# Access Compliance Report

## Public Rights-of-Way

Intersection ID: 17739	Main Street: E_WOODLAWN_RD	Cross Street: SOUTH_BV	Location: NW
ADA ID: 98EC45372836	Ramp Type: Perp	Initial Pass/Fail: Fail	Overall Compliance: No
Severity Score: 37.5			
Codes/Mitigation Info/Possible Solution		Field Measurements/Component Compliance

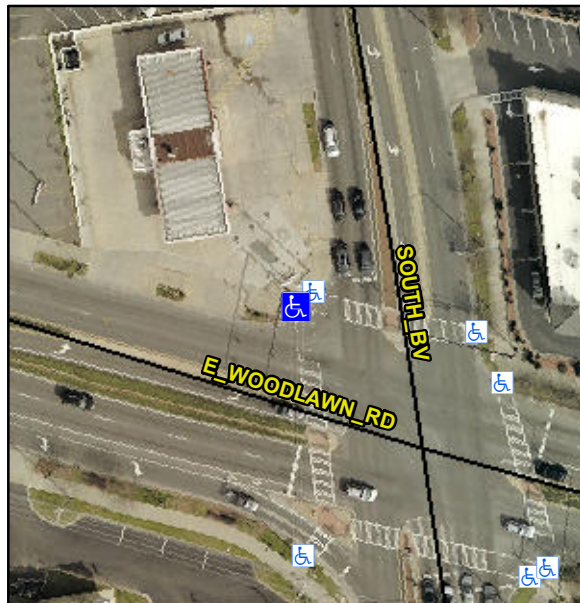
**R304.2.2, R304.5.3**

Compliance	Description	Data	Compliance	Description	Data
N/A	Ramp Length (in)	61.0	No	Ramp Slope (%)	12.1
Yes	Ramp Width (in)	88.0	No	Ramp XSlope (%)	5.8
N/A	Flare Type LT	N/A	N/A	Flare Type RT	N/A
N/A	Flare Slope LT (%)	N/A	N/A	Flare Slope RT (%)	N/A
N/A	Flare Traversable LT?	N/A	N/A	Flare Traversable RT?	N/A
N/A	Landing Length (in)	N/A	N/A	DWS Provided?	N/A
N/A	Landing Width (in)	N/A	N/A	DWS Contrast?	N/A
N/A	Landing Slope (%)	N/A	N/A	DWS Length (in)	N/A
N/A	Landing X Slope (%)	N/A	N/A	DWS Full Width?	N/A
N/A	Landing Curb? (Y/N)	N/A	N/A	DWS Offset (in)	N/A
N/A	Shared Landing?	N/A			
N/A	Gutter Ponding?	N/A	N/A	Gutter Slope (%)	N/A
N/A	Gutter Lip Ht (in)	N/A	N/A	Gutter X Slope (%)	N/A
N/A	Painted X Walk1?	Yes	N/A	Painted X Walk2?	N/A
	X Walk 1 Direction	To S		X Walk 2 Direction	N/A
N/A	X Walk 1 Width (in)	109.0	N/A	X Walk 2 Width (in)	N/A
	X Walk 1 Slope (%)	1.3		X Walk 2 Slope (%)	N/A
	X Walk 1 X Slope (%)	2.9		X Walk 2 X Slope (%)	N/A

**Remove & Replace Entire Ramp.**
